Model	Pigeon A and B	**Volt/Hz**	**Date of Modification**	**Serial Number**
Modified Article	Parts Catalog			
Reason for Modification	Parts catalog correction

Model	Pigeon A and B	**Volt/Hz**	**Date of Modification**	**Serial Number**
Modified Article	Exteriors and Operating Instructions			
Reason for Modification	Aurora version information (Pigeon A only)

Part Number	Index No.	Page
AB013201	20	52

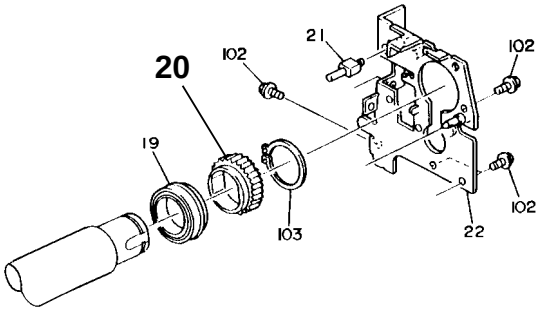
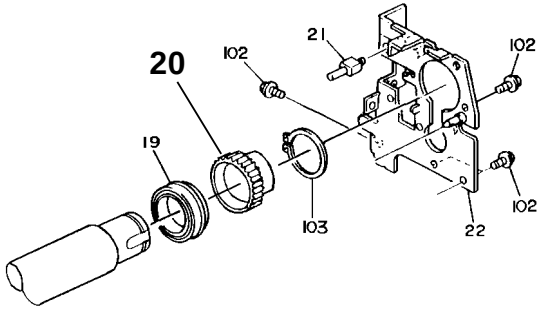
5. Please correct the parts catalog illustration for the following part:

NOTE: The gear's flange should face out.

Part Number	Description	Q'ty Used	Index No.	Page
A3181195	Mounting Bracket MB10 (ADDED)	1	18 → 66	2

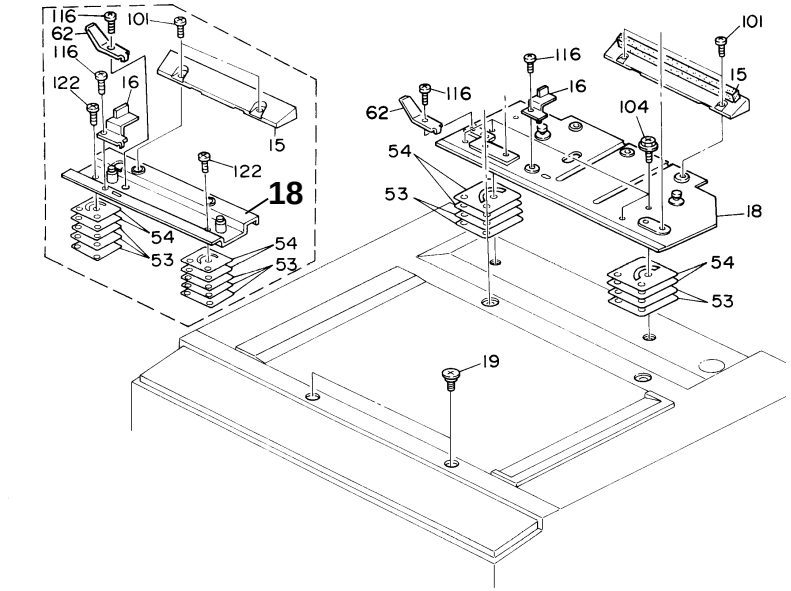
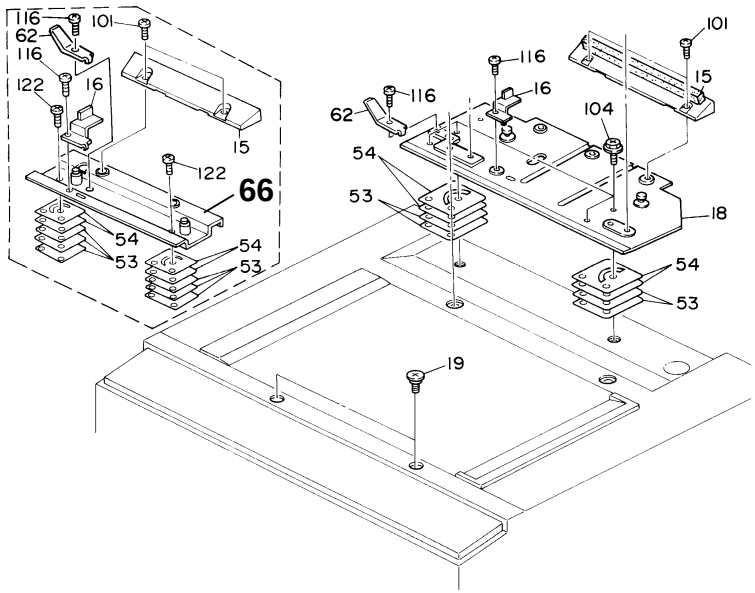
7. Please correct the index number on your parts catalog illustration as follows:

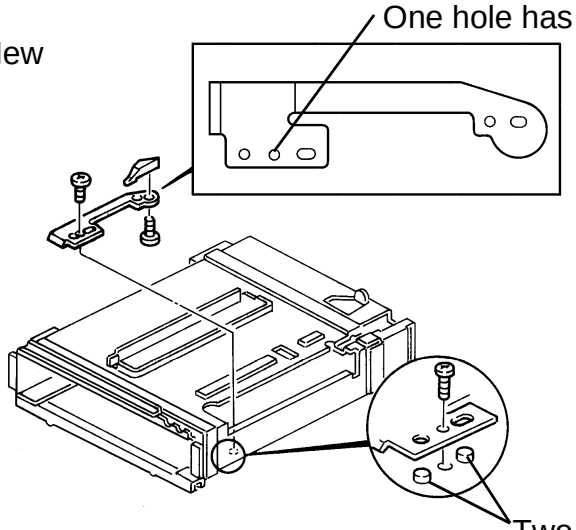
To ensure mounting of the release spring and reduce the thrust play of the release spring, the mounting method of the release spring has been changed as shown.

The release spring was secured by two screws.	→	The position of the relase spring has been fixed by two positioning pins on the base plate and secured by one screw.

Note: New release spring (P/N A1101195) can be secured on the old machines without two positioning pins.

New DC Power Supply Board Schematic

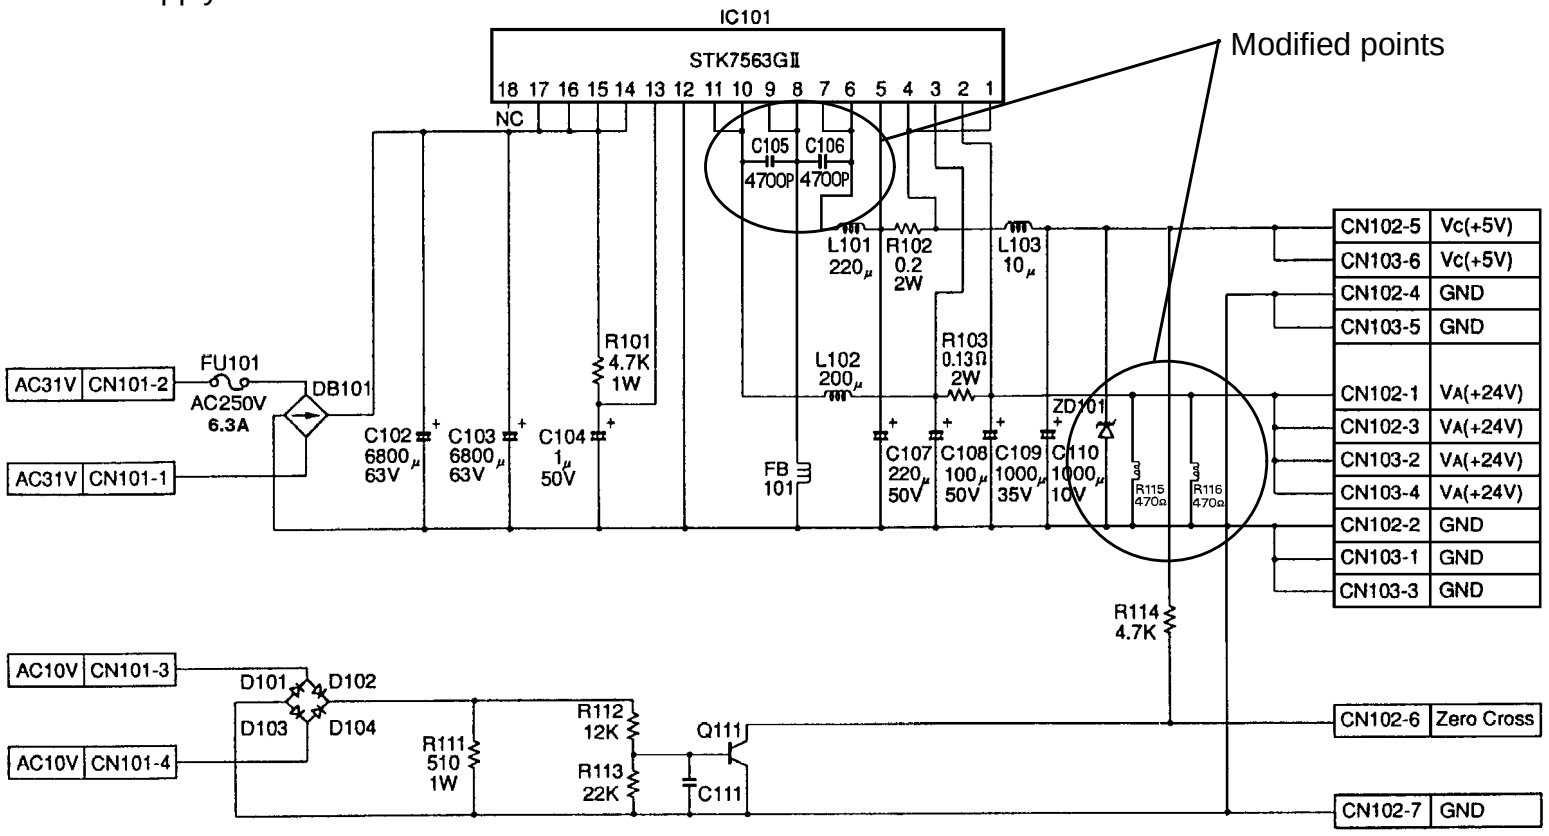
To prevent high pitched noise from the dc power supply board, the dc power supply board has been changed as follows:

1. Two 470Ω resistors (R115, R116) have been added between the 24V line and GND.
2. Two capacitors (C105 and C106) have been changed from 2200pF to 4700pF.
3. The width of the ground pattern has been increased.
